CONDENSER IA

FILMED
 MAY 20 1974
 RELEASE FOR MFR.
 RECEIVED
 MAY 1 1974
 INDUSTRIAL PRODUCTS DIVISION
 MARYLAND SHIPBUILDING & DRYDOCK CO.
 BALTIMORE, MD.
 46,000 SQ. FT. SURFACE CONDENSER
 SOLE PRESS. DIVIDED FROM TWIN SHELL
 (CONCLUDED 10)
 FOR CONSUMERS PUBLIC POWER DISTRICT
 DESIGNED BY: B&R:JES APPROVED BY: M.R.:S-3-68
 DRAWN BY: B&R:JES SCALE: DRWG. 3/4"=1'-0"
 CONT. NO. 93677 SHEET NO. EC93677GA

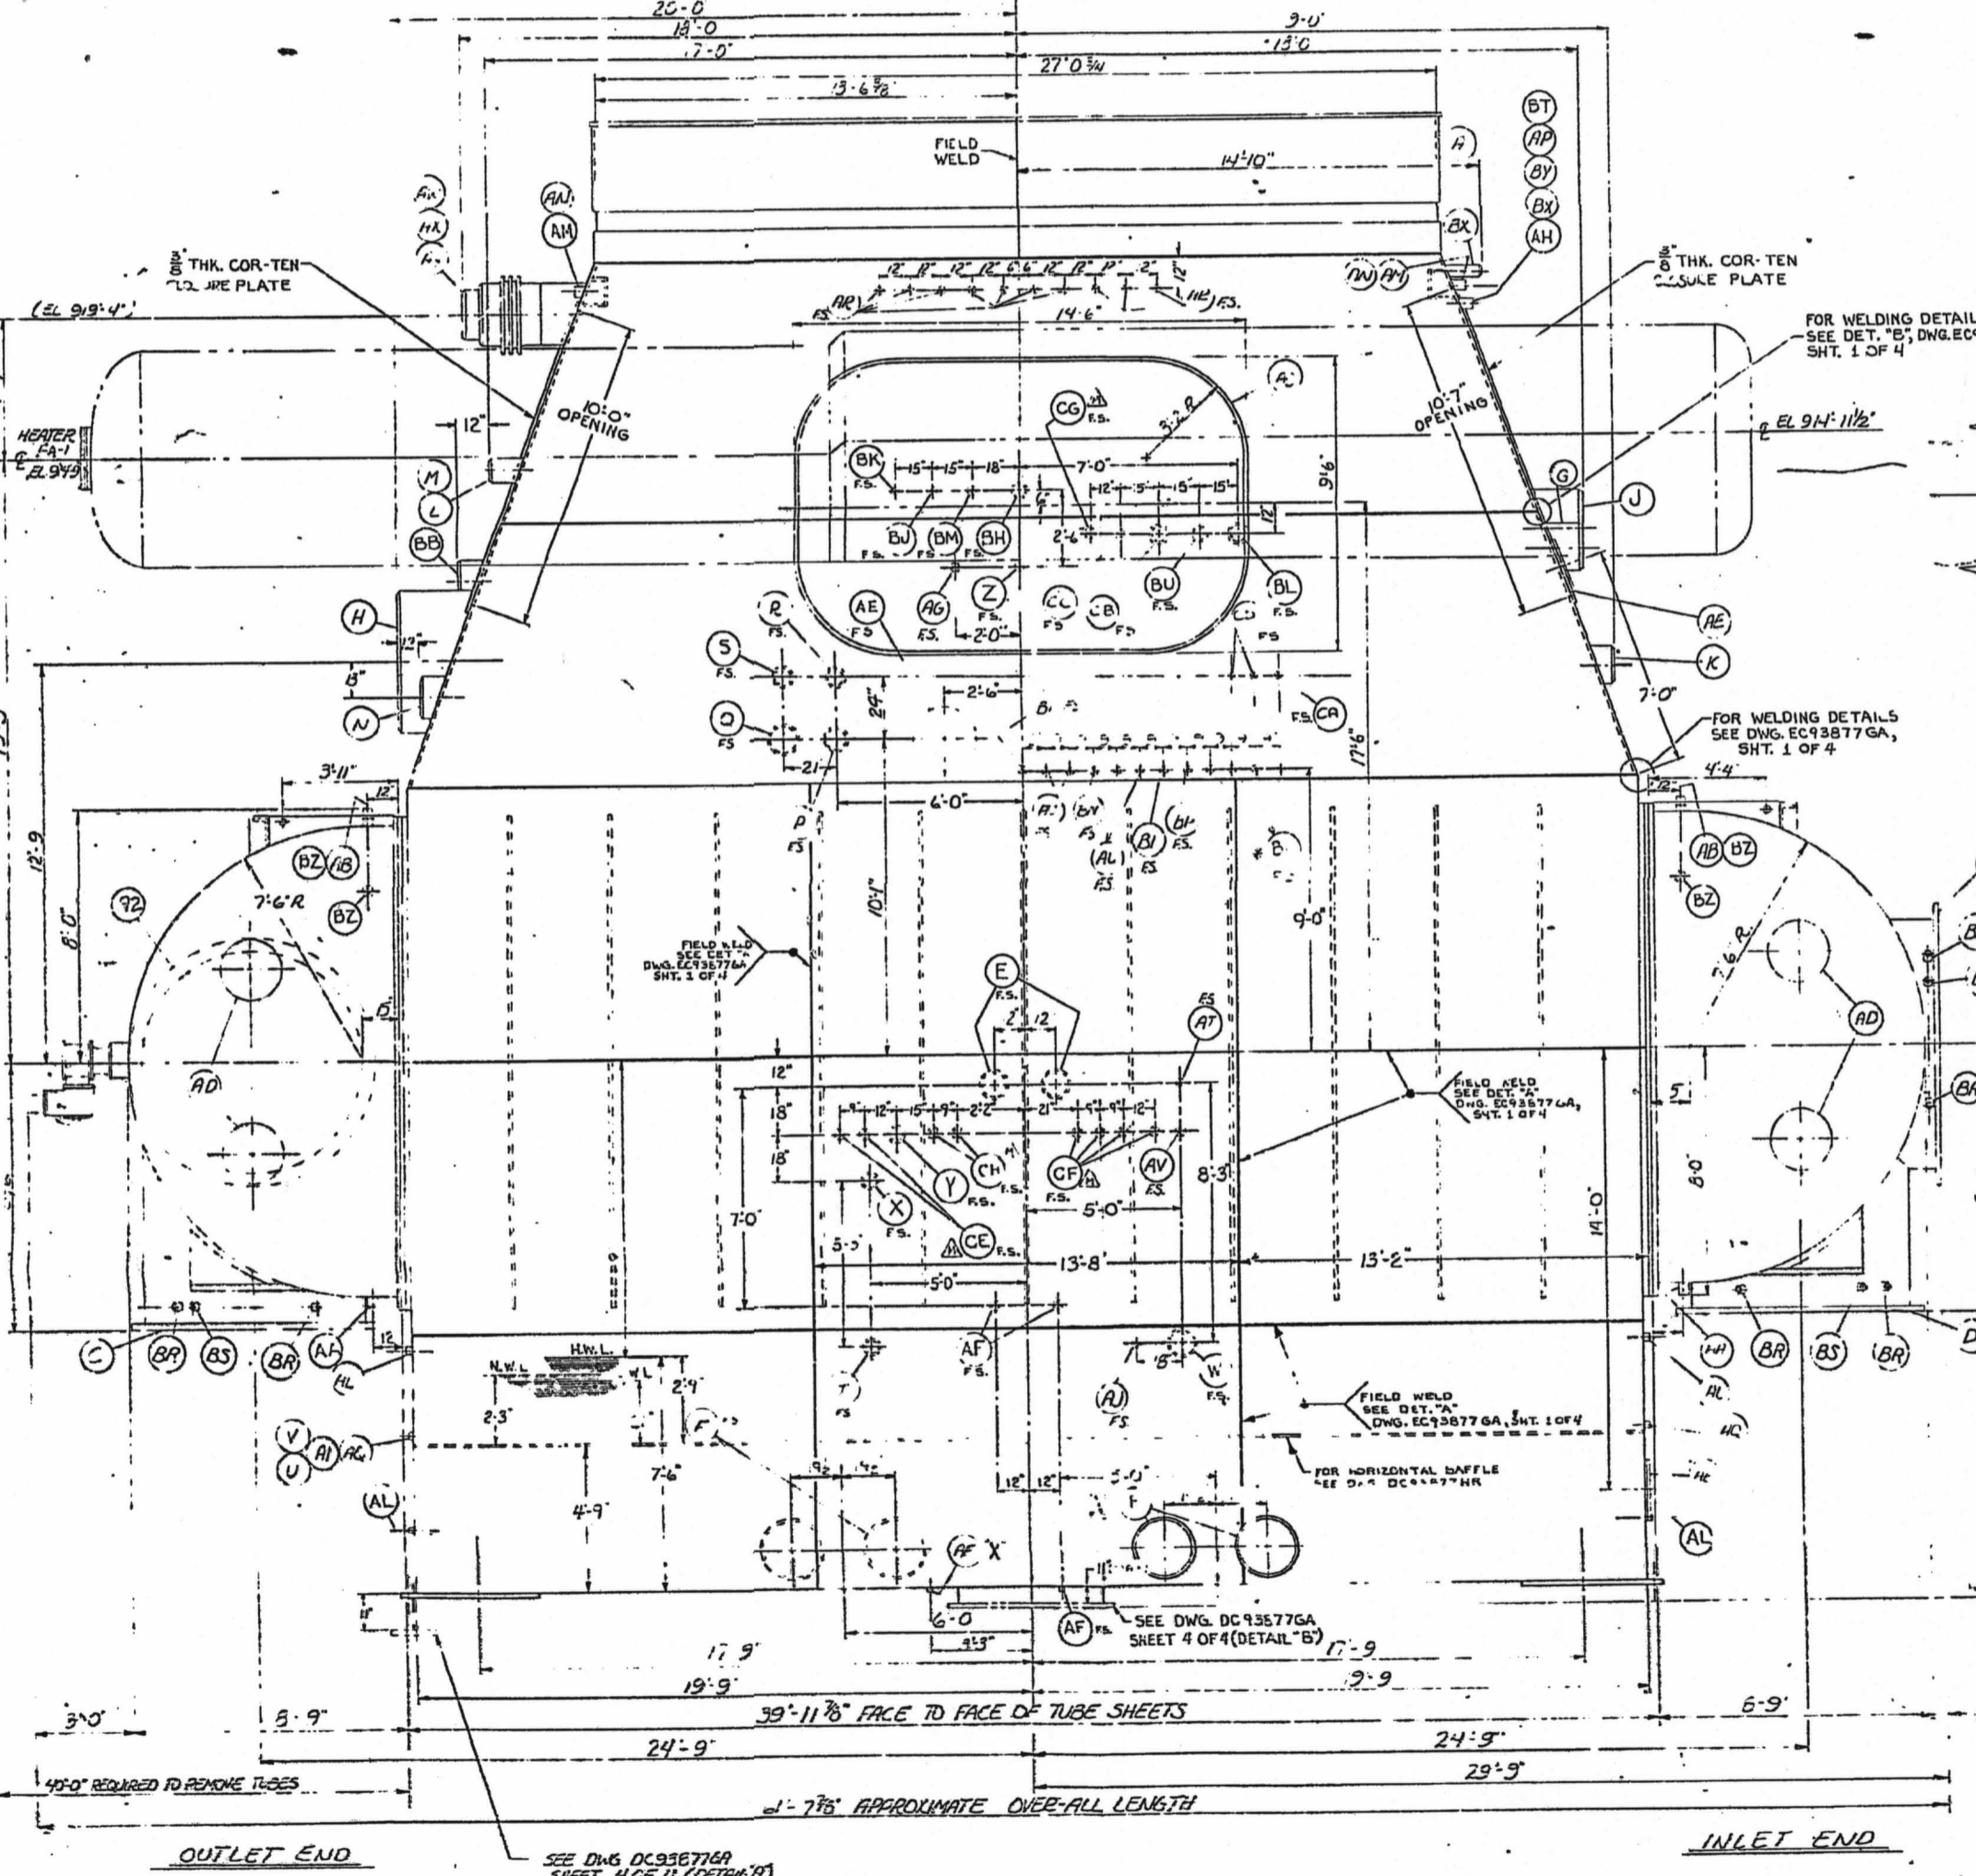
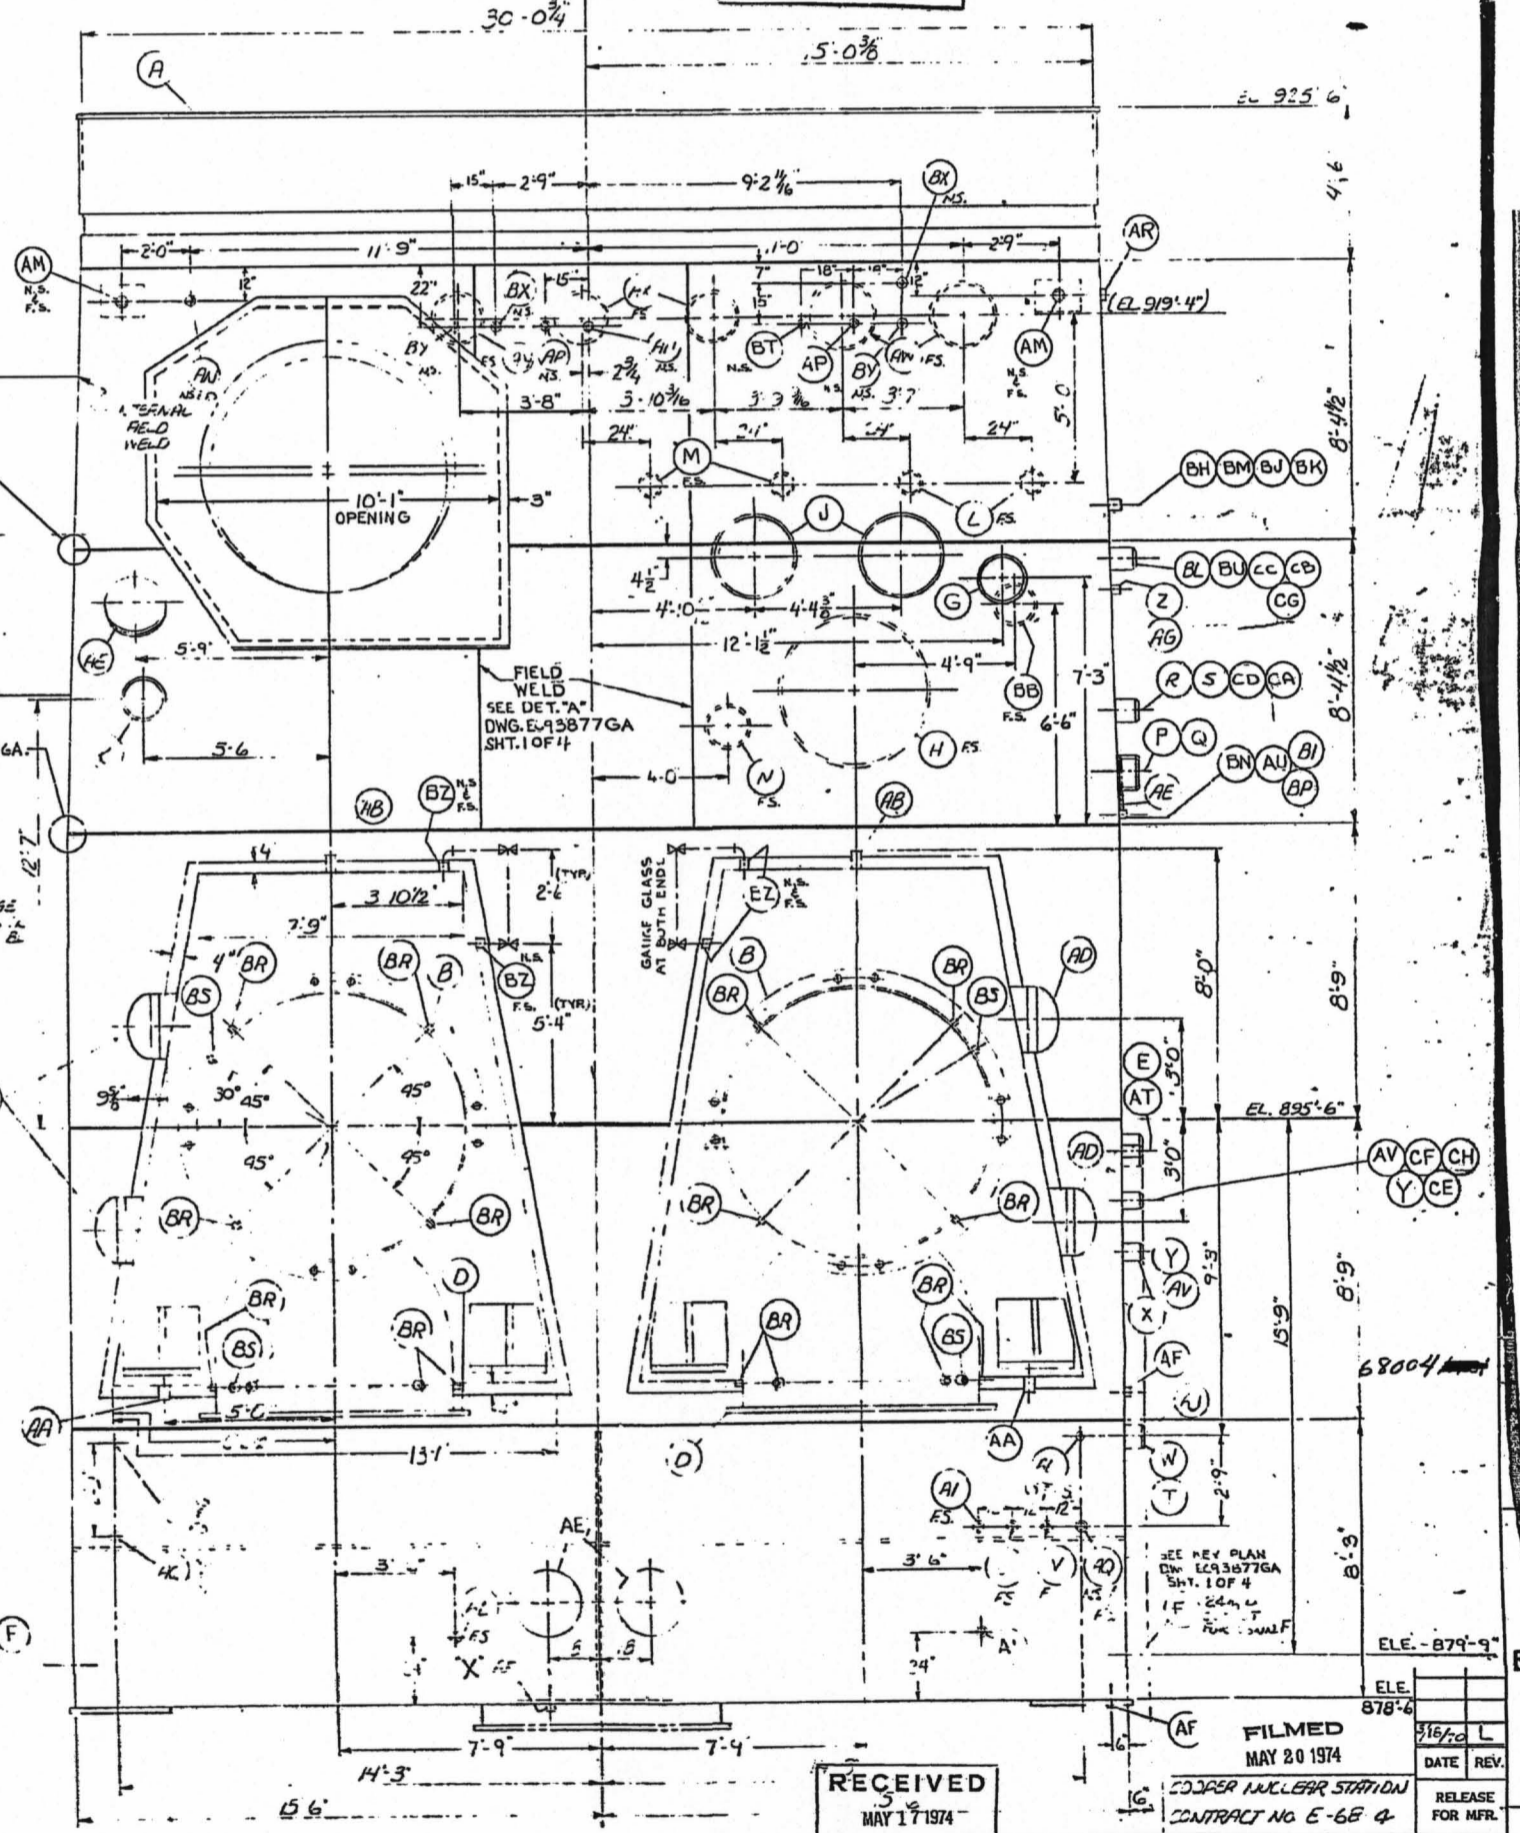
REV.	DATE	REVISION
A	1/18/68	REVISED PER B&R LETTER DATED 5-22-68 AND MARKED-UP PRINT DATED 5-20-68.
B	2/27/68	REORIENTED CROSS-OVER VALVE AT CONN. "AZ". REVISED AS PER BURNS & ROE LETTER DATED 8-15-68, AND MARKED-UP PRINT DATED 8-13-68. REDRAWN BY D.R.C. 10-22-68.
C	12/10/68	REVISED PER B&R LETTER DATED 11-13-68 AND MARKED-UP PRINT DATED 11-12-68. REVISED HOTWELL FOD AS PER BURNS & ROE DWG. M-134.
D	2/27/69	REVISED PER B&R LTR DATED 2-14-69 & MKD. PRT. DATED 1-17-69.
E	2/27/69	REVISED PER B&R LTR DATED 2-14-69 & MKD. PRT. DATED 2-3-69.
F	4/10/69	REVISED PER B&R LTR DATED 4-4-69 & MKD. PRT. DATED 3-28-69.
G	7/1/69	REVISED PER B&R LTR DATED 5-9-69 & MKD. PRT. DATED 5-7-69.
H	7/1/69	REVISED PER B&R LTR DATED 6-23-69 & MKD. PRT. DATED 6-21-69.
J	7/1/69	REVISED CONN. "B 5" AS PER BURNS & ROE TELEPHONE CONVERSATION.
K	7/1/69	REVISED PER B&R LTR DATED 7-30-69 & MARKED-UP PRINT DATED 7-27-69.
L	3/11/70	REVISED VERTICAL FIELD WELDS AT INLET-OUTLET ENDS IN SLOPE SECTION ONLY.

M	4/21/70	ADDED CONN. "CE", "CF", "CG", & "CH" AS PER B&R LTR DATED 3/24/70 AND MKD.-UP PRINT DATED 3/24/70.
